## Product / Process Change Notification (PCN)

**PCN #:** PCN\_IndFC\_20191101

**Affected Series:** WE-FC-Series

**PCN Date:** August 12, 2019

Size ET

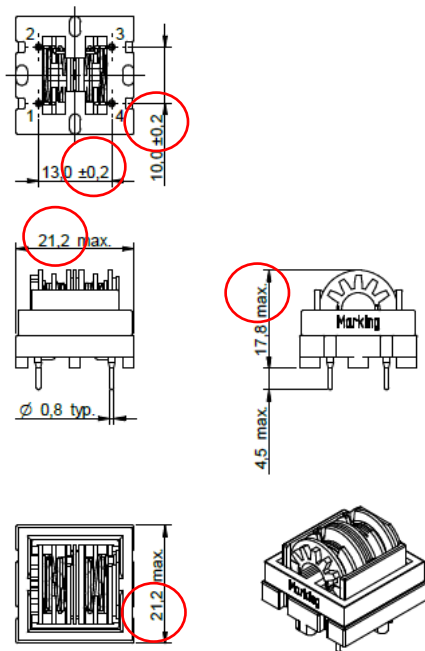
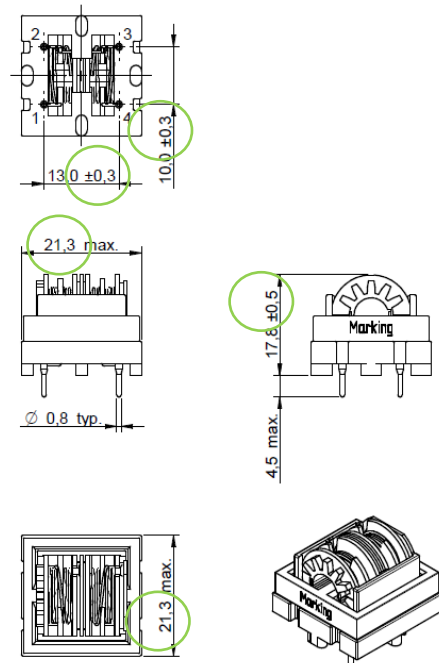
**1. Update the mechanical dimensions (no change of the part)**
